MEMORANDUM

SUBJECT: Negative Declaration for the Pier 38 Marine Research Facility TMK-1-5-42: 6
and 7 (portion), Honolulu Harbor, Oahu, Hawaii

**Pier 38 Master Plan
FINAL Environmental Assessment**

Schematic Site Plan

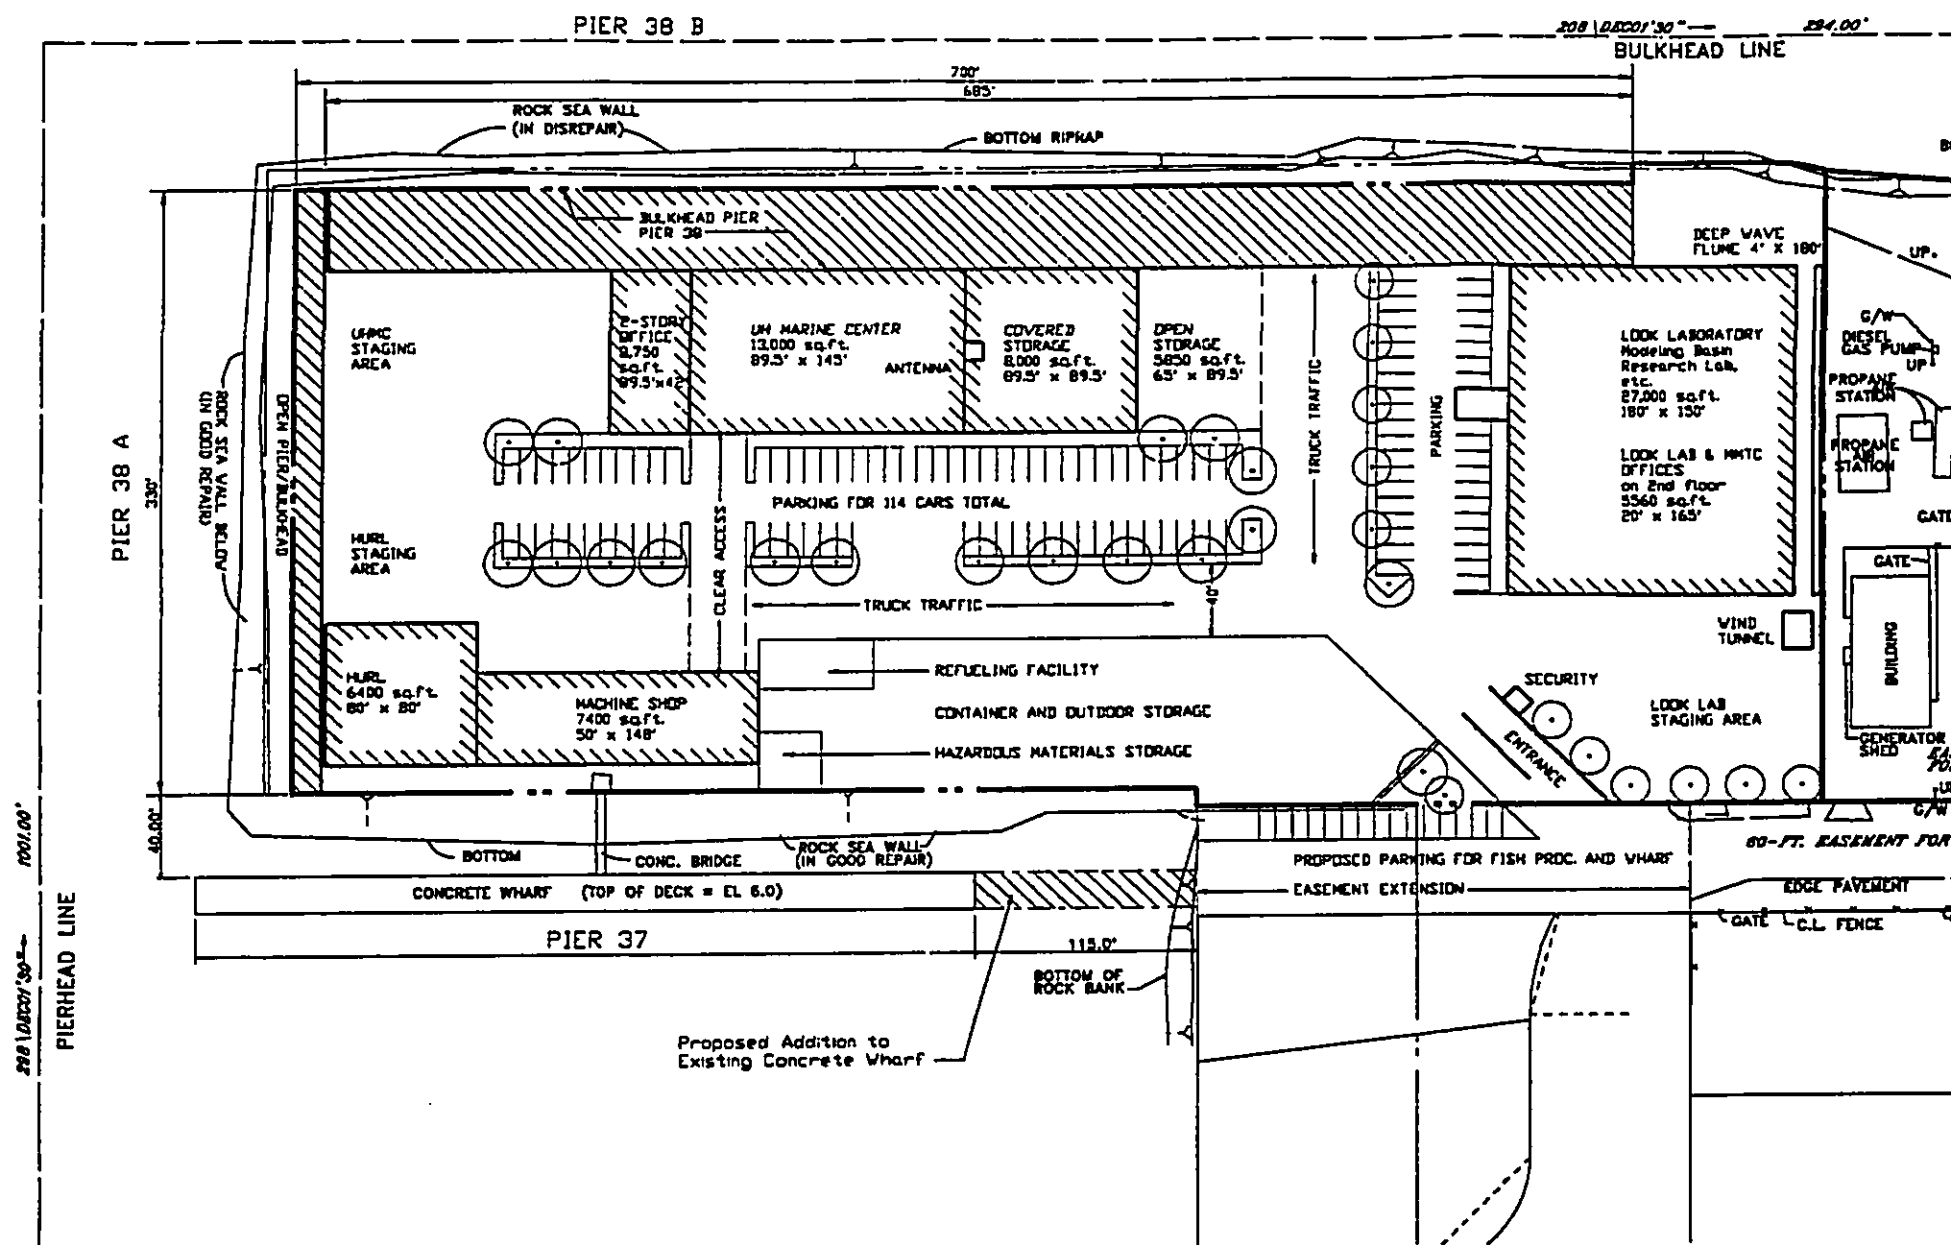
There is also the question of the loss of an additional 9000 sf of U.H. land at Pier 38B by dredging to widen the slip, as discussed on page 3-1 of the EA. Is this due to the design incorporated into construction of Pier 38B or to maintain a 345 foot slip width? If it is the latter, the U.H. should not bear the full impact, i.e., the Pier 39 redevelopment should be impacted as well to preserve the extremely limited land area available at the Pier 38 site. It should also be noted that visiting UNOLS ships have beams exceeding 52 feet. In addition, there is no floating dock depicted in Figure 2 as referenced on page 3-2 of the EA.

There is some contradiction in the EA regarding the width of the apron on Pier 38A. Figure 2 of the EA appears to show a 15' apron. HURL operations require that the outboard wharf (Pier 38A) fronting their building be 45' wide to facilitate the loading and unloading of large seagoing equipment and to provide access to the area with large trucks and cranes. This could be accomplished by relocating the HURL building footprint 30 feet to the north.
